ADDENDUM No. Two (2)

IFB No. 2019-183

CONSTRUCTION, REROOF COLLIN COUNTY 920 E. PARK BLVD., PLANO

ADDENDUM NUMBER 1

8750 N. Central Expwy.
Suite 725
Dallas, Texas 75231
Voice 214-363-2192
Fax 214-818-9813

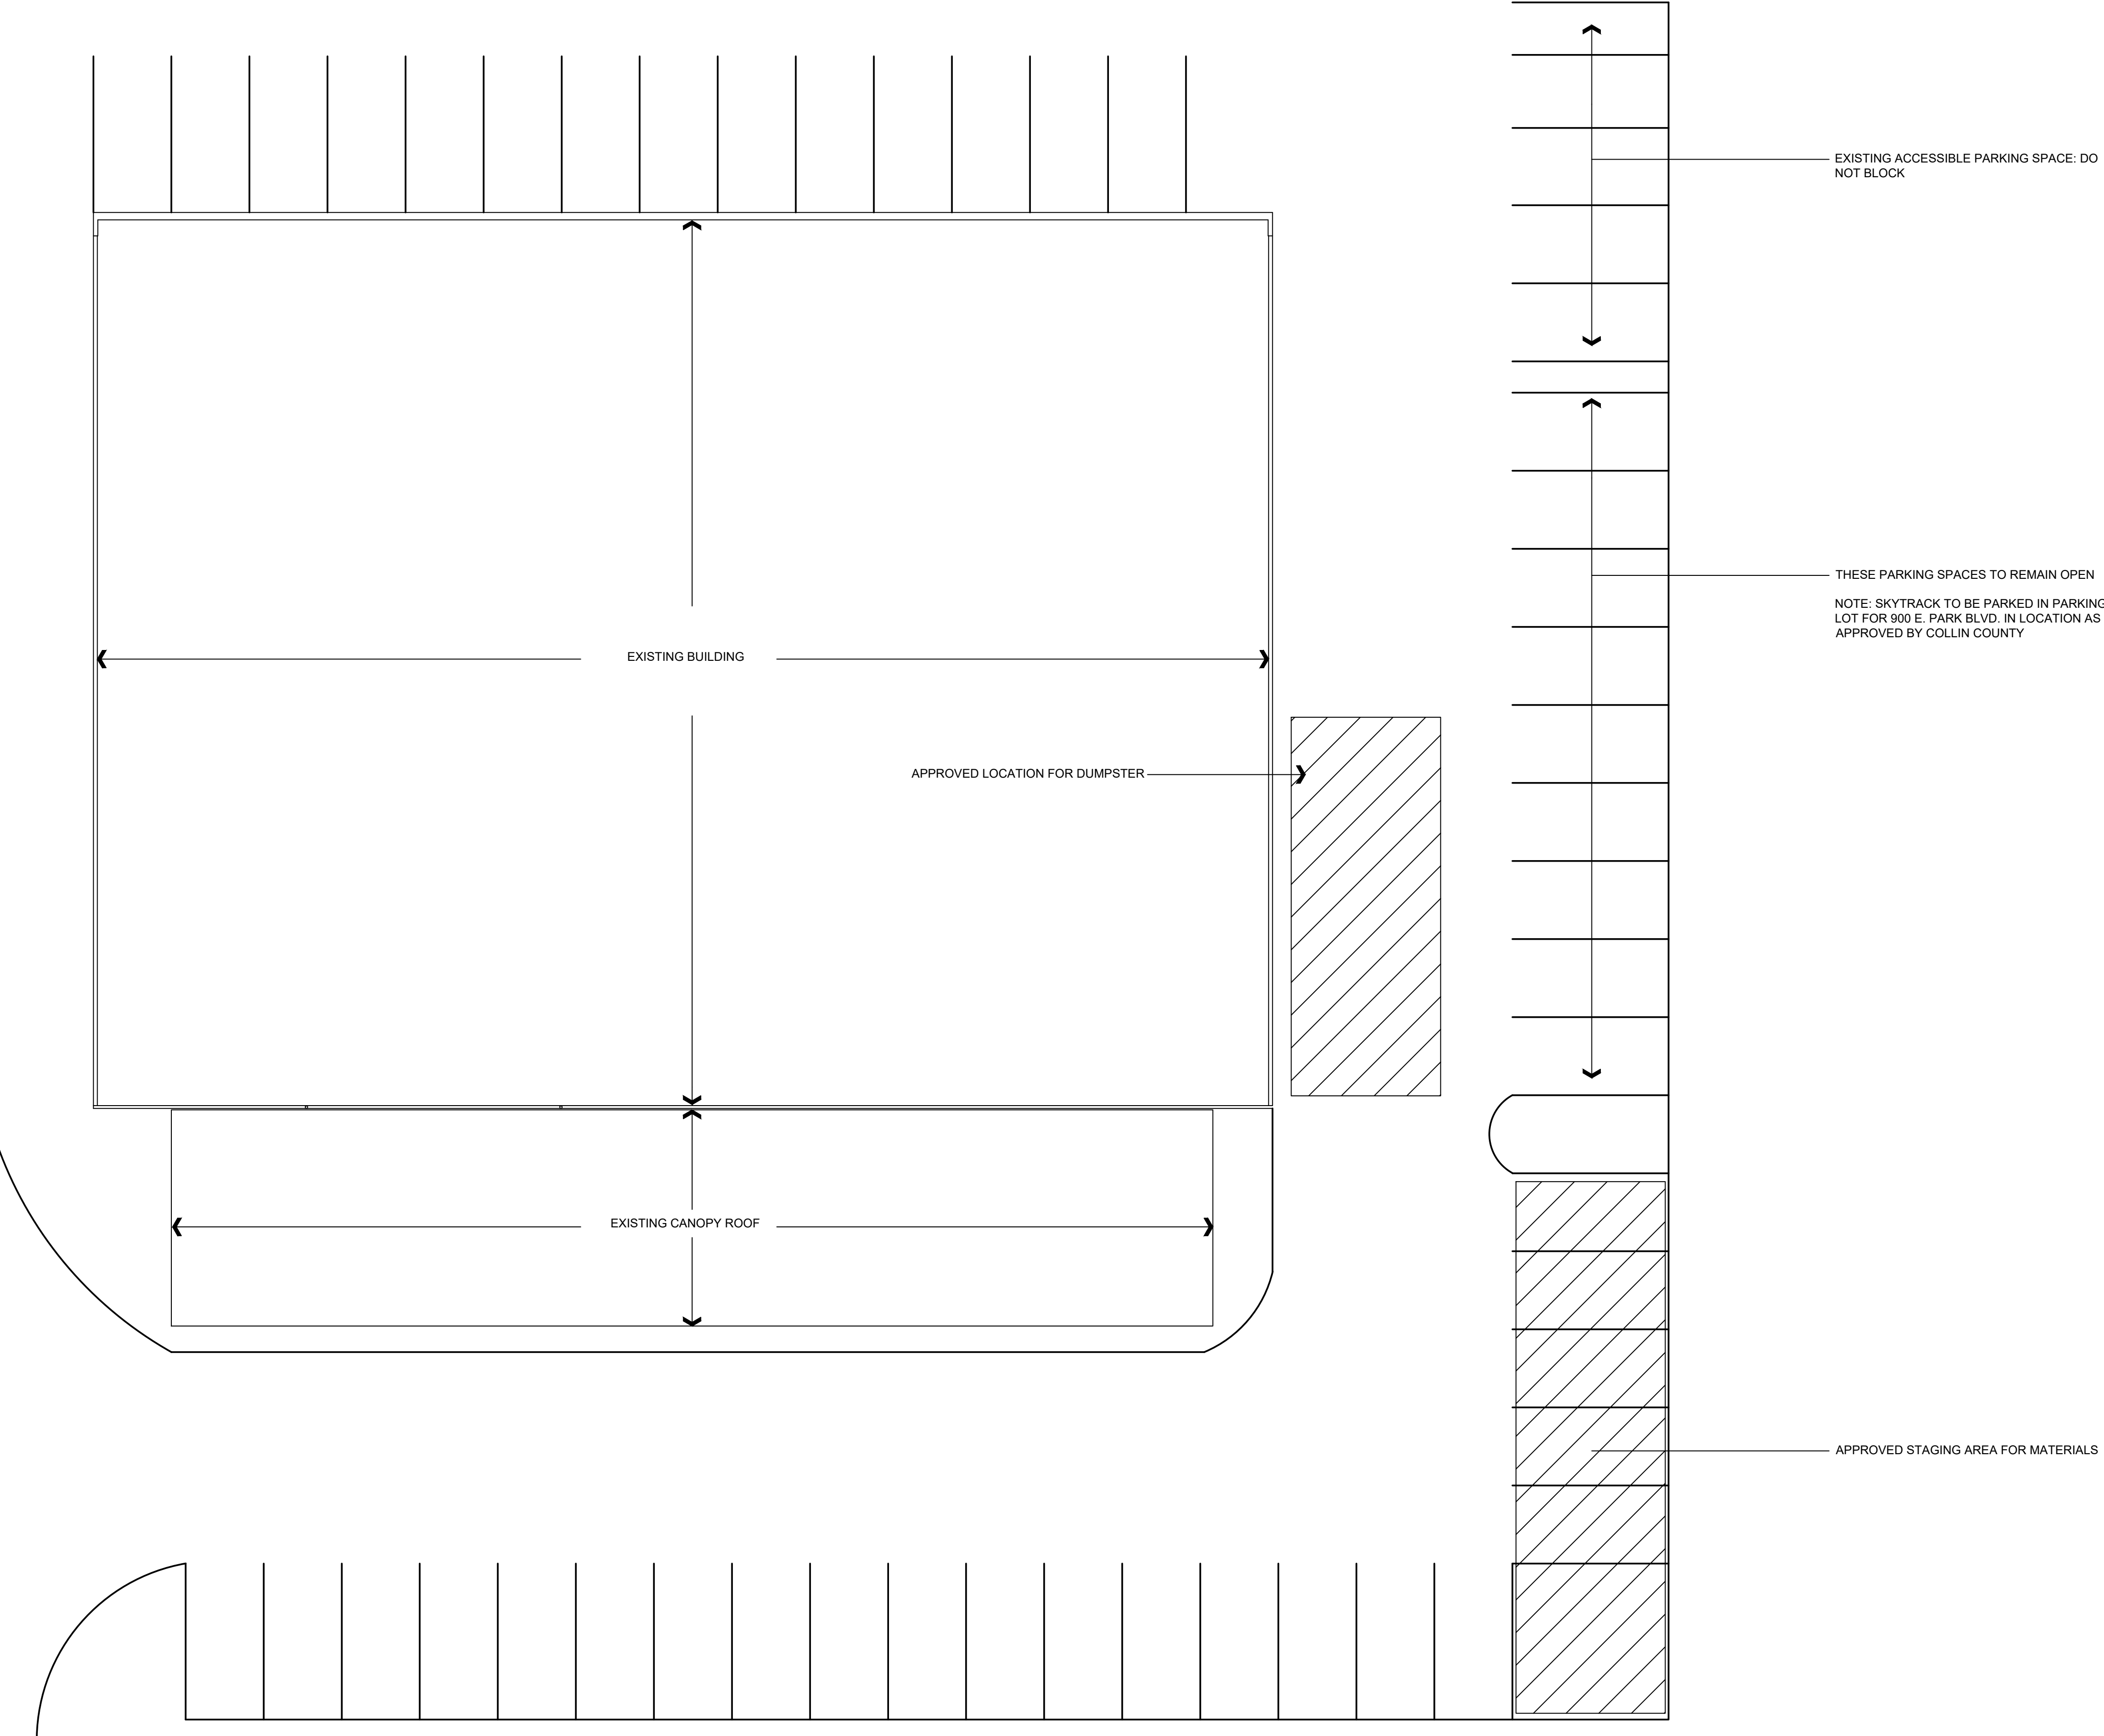
1. The attached revised Sheets R1.0, R1.1 and R2.1 replace the original Sheets R1.0, R1.1 and R2.1 with the changes associated with the Addendum being noted and clouded.
2. The attached Sheet R2.2 is added to the Contract Documents and includes information related to where a dumpster can be positioned, where roofing materials can be staged and where the sky track can be parked.
